PUBLIC HEARING FOR PLANNING DETERMINATION

Application Number:	2232-S18-31
Applicant:	Fairfax County Department of Public Works and Environmental Services (DPWES)
Proposed Use:	Salt Storage Facility – Central Material Facility (CMF)
Supervisor District:	Springfield District
Subject Property Address:	5414 Ladue Lane, Fairfax, VA 22030 Tax Map 67-4 ((1)) 19
Area of Subject Property:	11.4 acres
Application Accepted:	February 4, 2019
Recommendation:	In accordance with Va. Code Sec. 15.2-2232, as amended, staff recommends that the Planning Commission find that the proposal by the Fairfax County DPWES, to construct a salt storage facility at 5414 Ladue Lane, Fairfax, VA 22030, <u>is substantially in accord</u> with provisions of the adopted Comprehensive Plan.

Section 15.2-2232 Review
Salt Storage Facility
Central Material Facility Site (CMF)
Project Number SD-000031-174
November 2, 2018
Revised: January 10, 2019, April 14, 2019

Reference: Central Material Facility (CMF)
Project Number SD-00031-174
2232-S18-31 Determination Resubmission-Comment Response Letter

Drawing Title
2232
SITE EXHIBIT

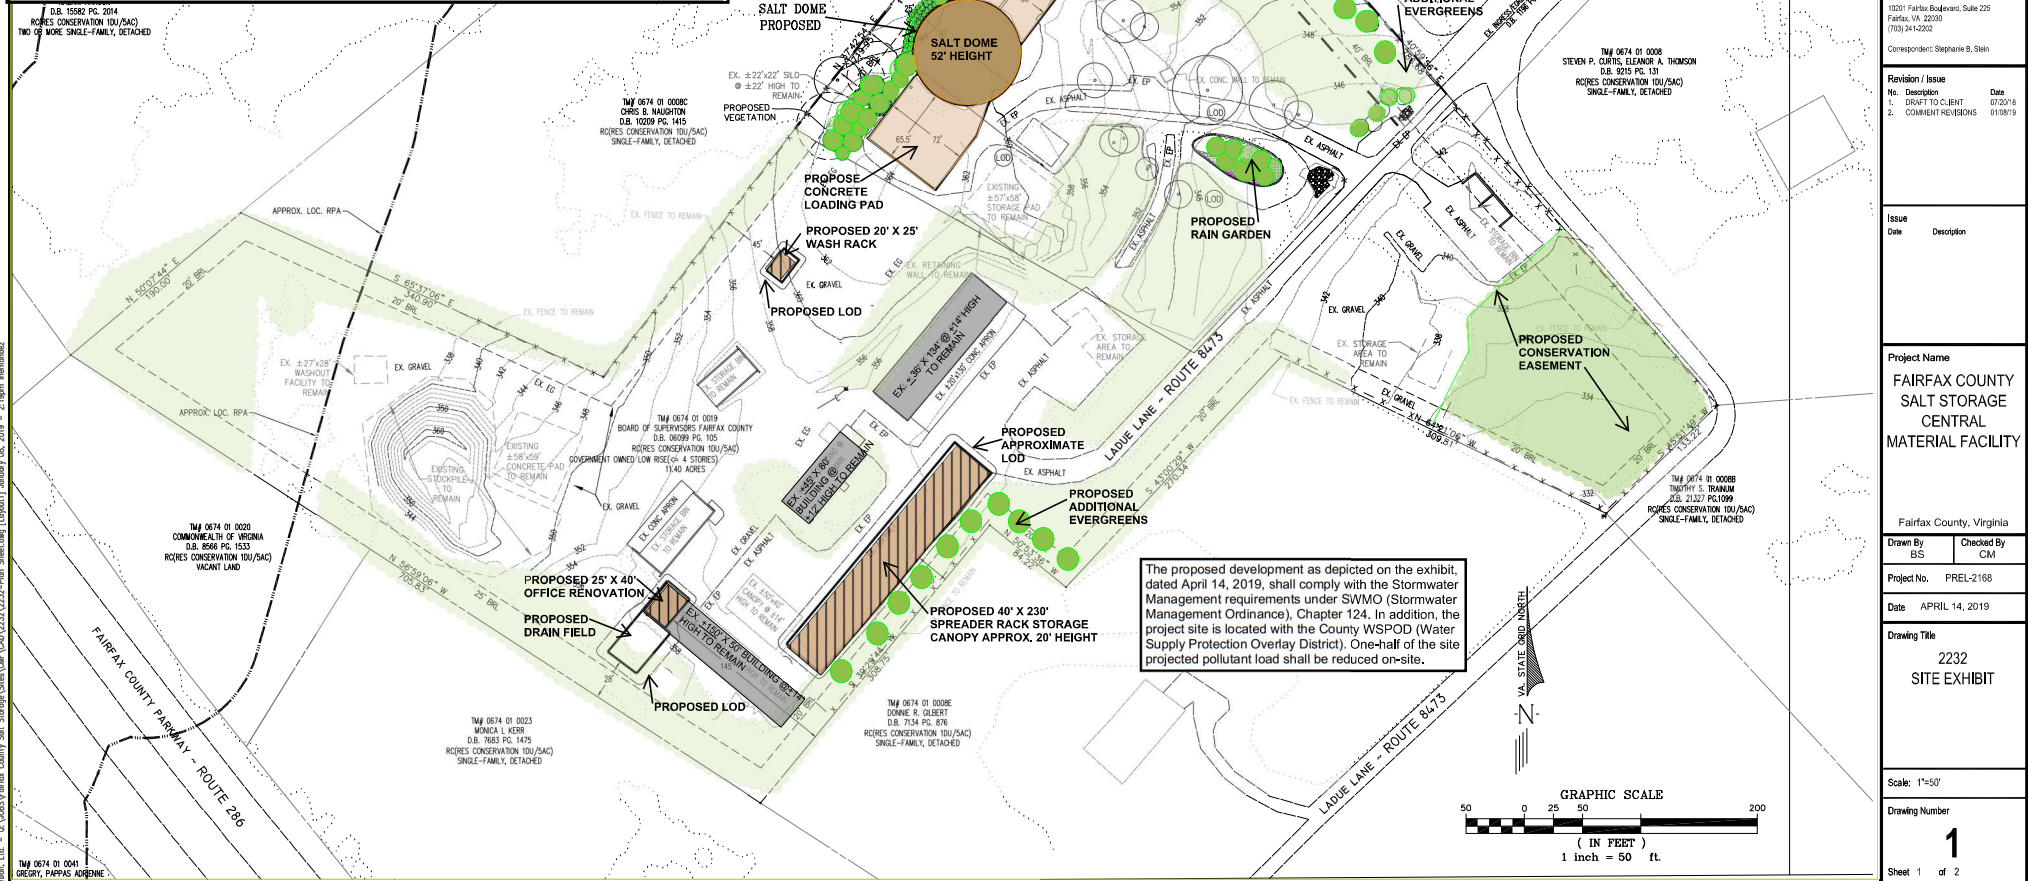
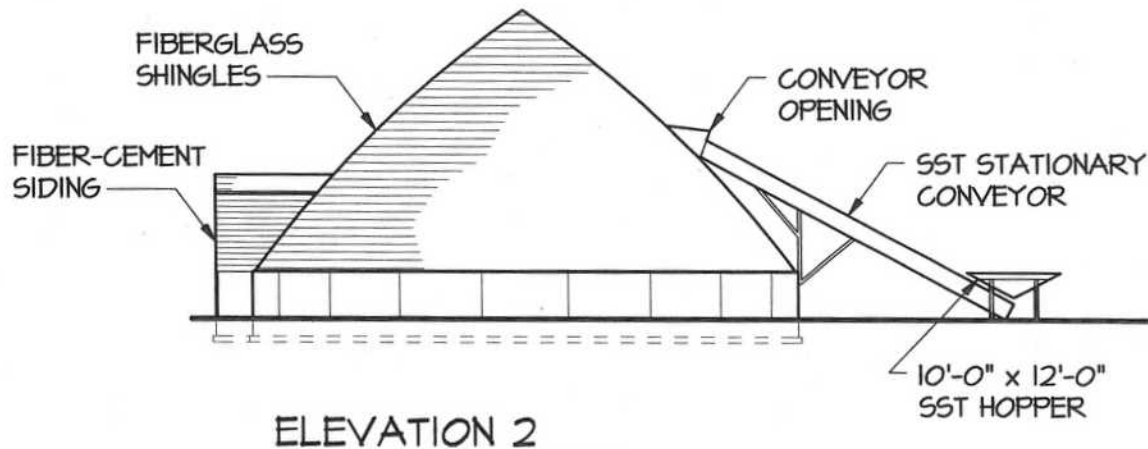
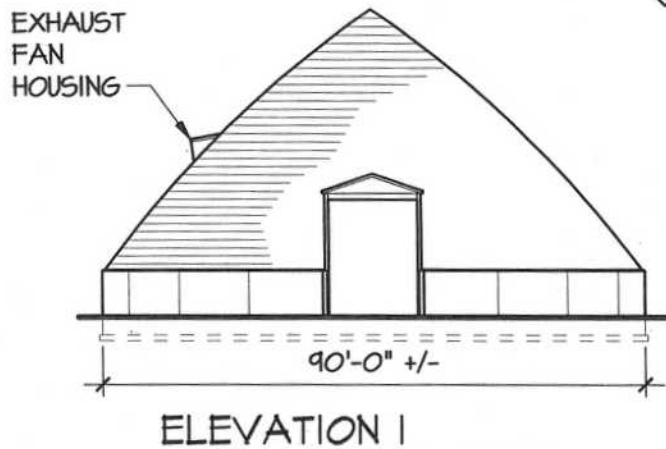
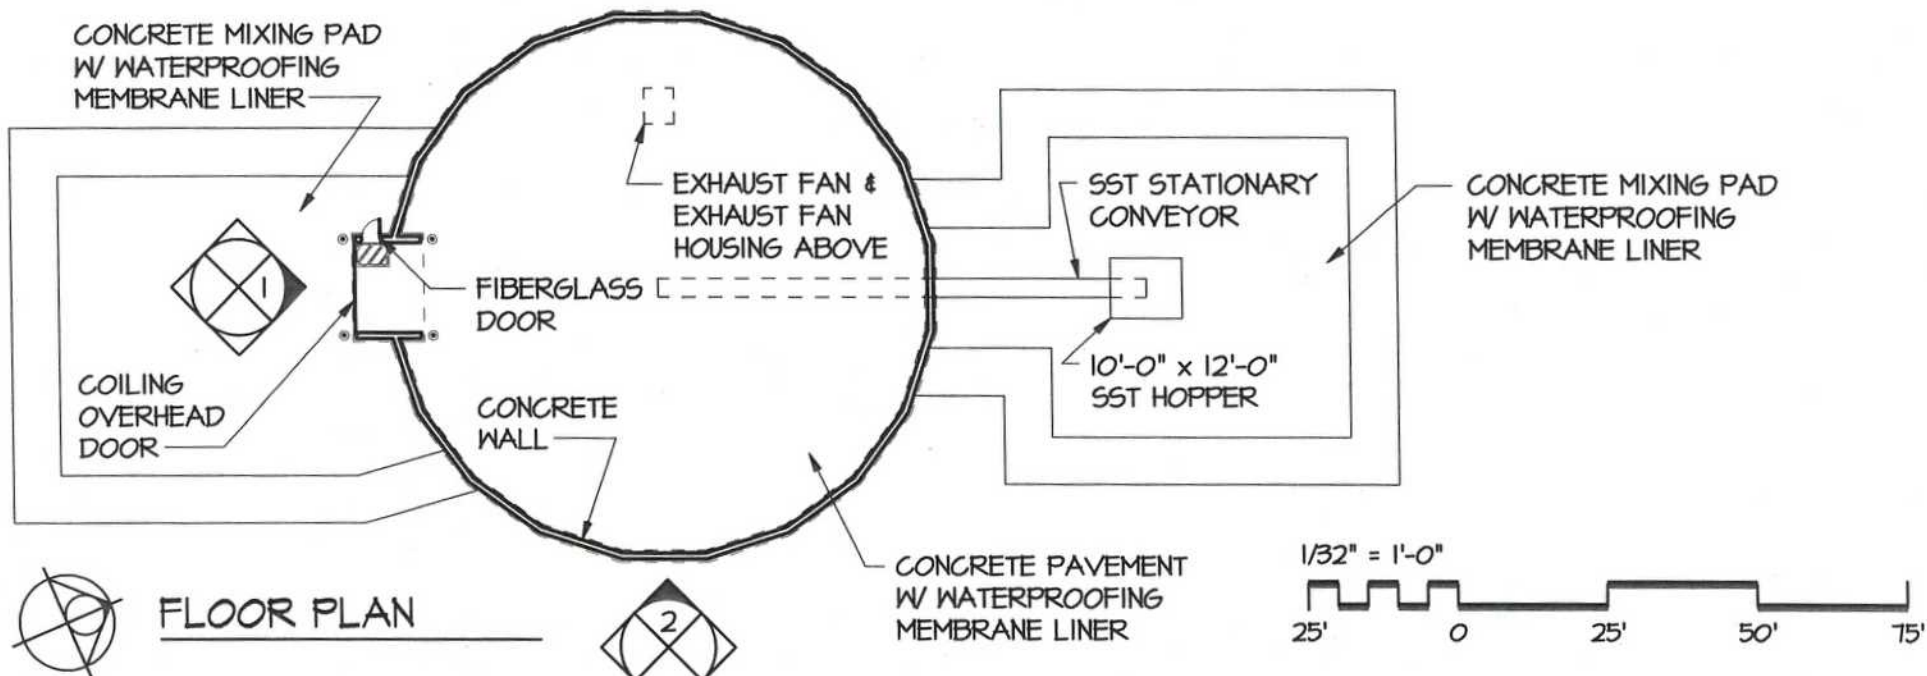
1. Comment: The plans depict a "proposed underground storage tank", but there is no mention of this in the application package. This should be addressed.

- 2. Comment:** The statement includes the option for potential bioretention facility on site but there is no proposed location for this on the plat. However, the applicant has indicated a location for proposed vegetation, is the applicant considering placing these in the same location? This should be clarified.

Response: The salt dome contains concrete loading pads for loading the salt into the dome and for loading the salt into the trucks for distribution during snow events. These pads are noted on the Site Plan sheet number 1. During winter months, the storm

run-off and rinsate will be directed to the two-underground storage tanks where it is collected and will be pumped and hauled for discharge into an approved location as coordinated with Wastewater Management Division. All appropriate design and computations, as well as MS4 and stormwater run-off regulations, will be included in the development plans for the minor site plan review and approval.

Response: The proposed location for the bioretention facility not in the same location as the proposed vegetation on the west side of the dome facility. The bioretention facility is located north-east of the proposed underground tanks (where the existing asphalt trails connect) and is shown in the minor site plan documents submitted for review.

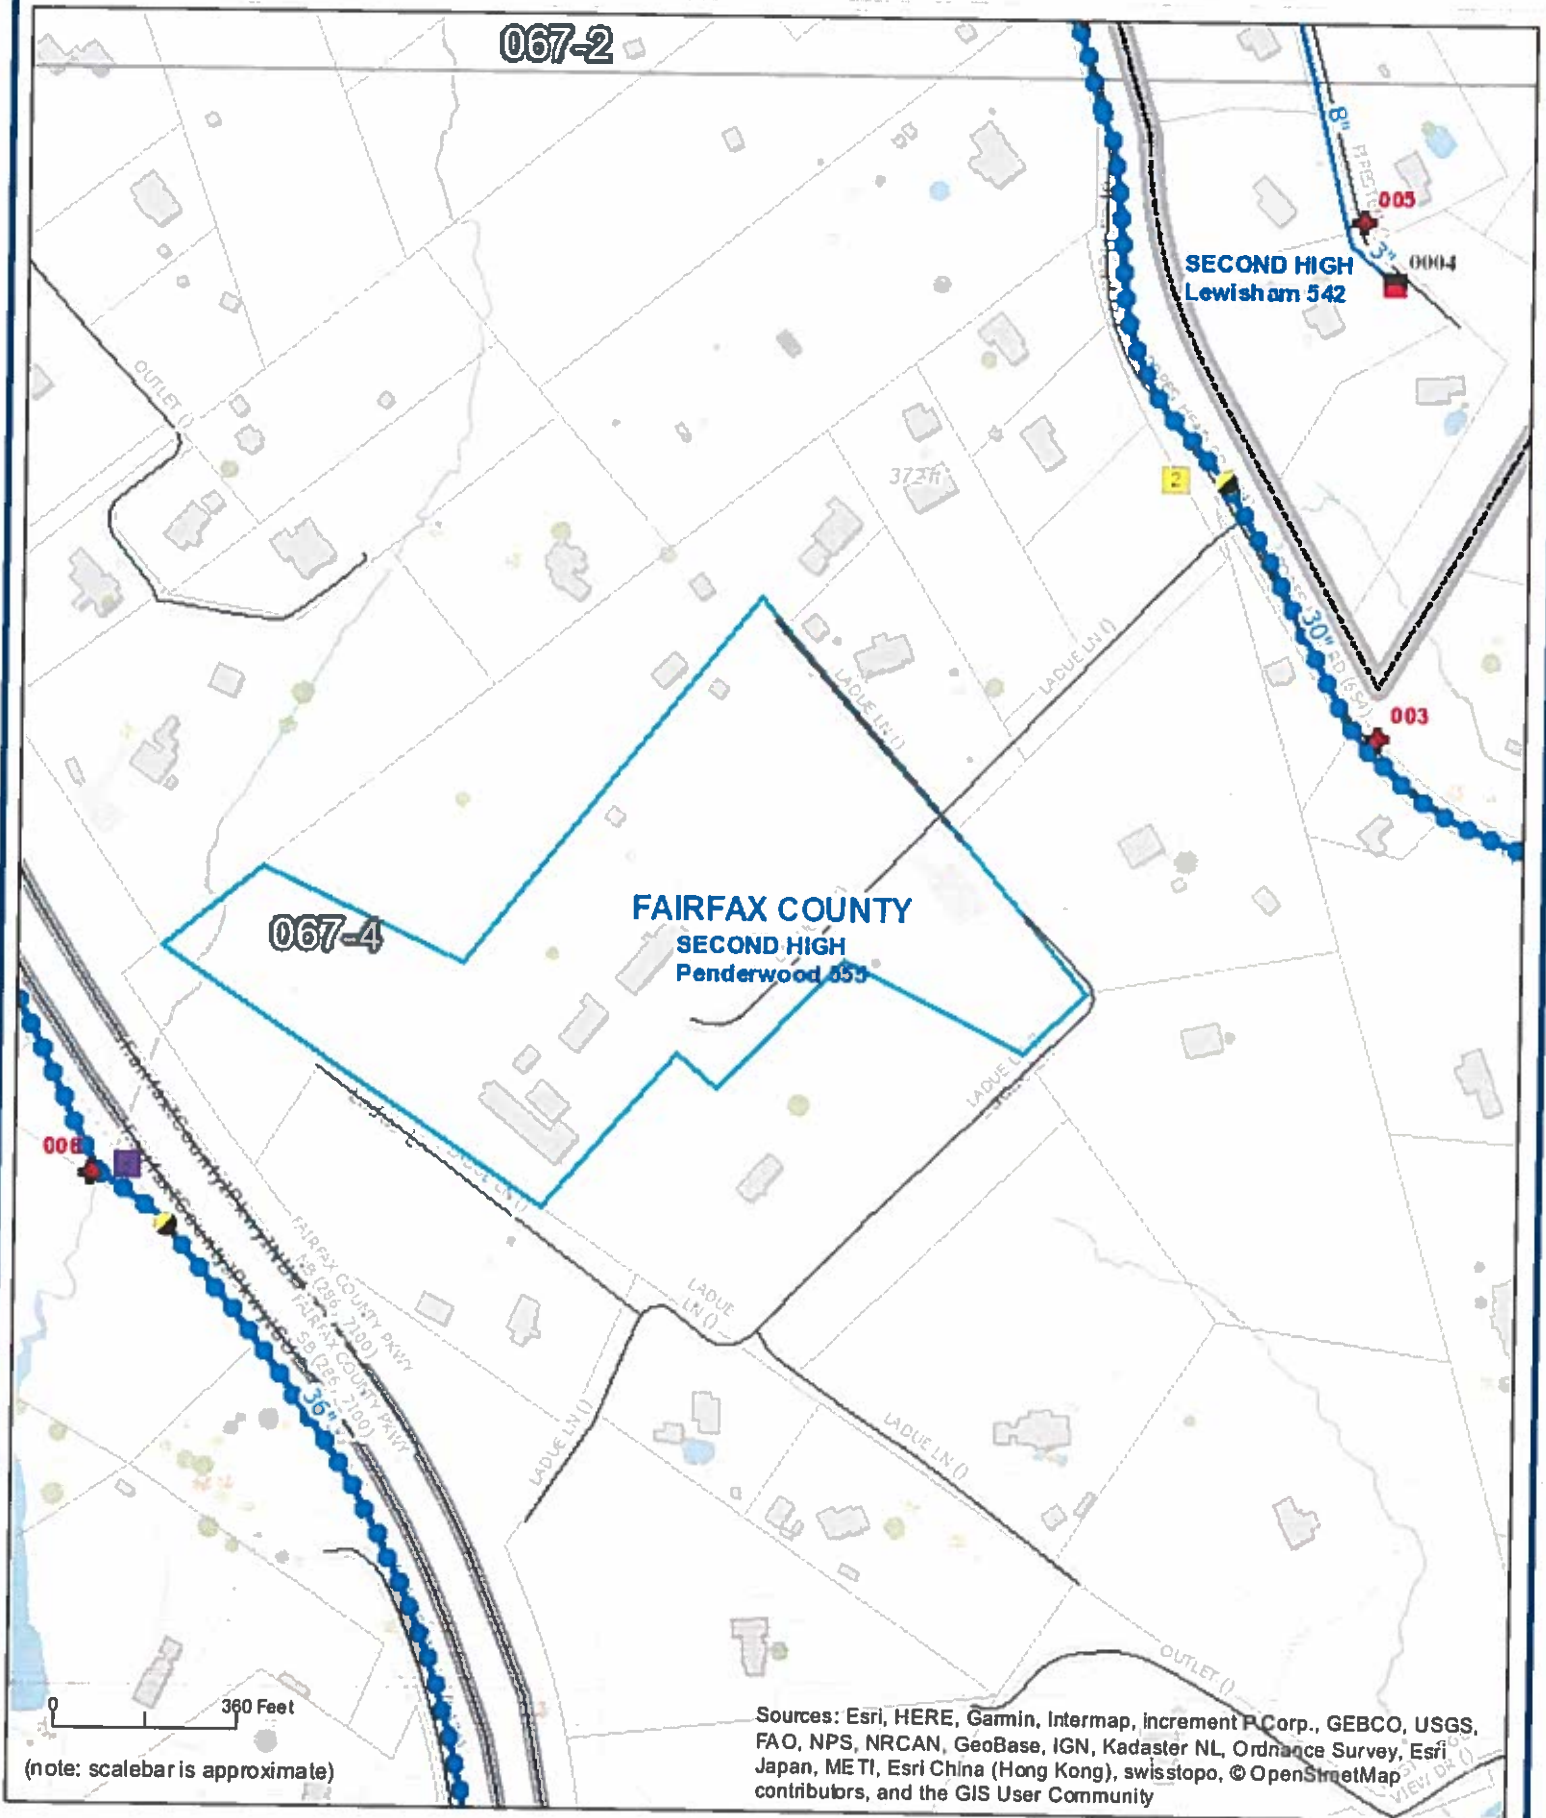
1. The property can be served by Fairfax Water.
2. The closest available water main to provide domestic service is an existing 8-inch water main located in Hexagon Place. The developer is responsible for all on-site and off-site facilities necessary to serve this project. See the enclosed water system map.

Response: Acknowledged.
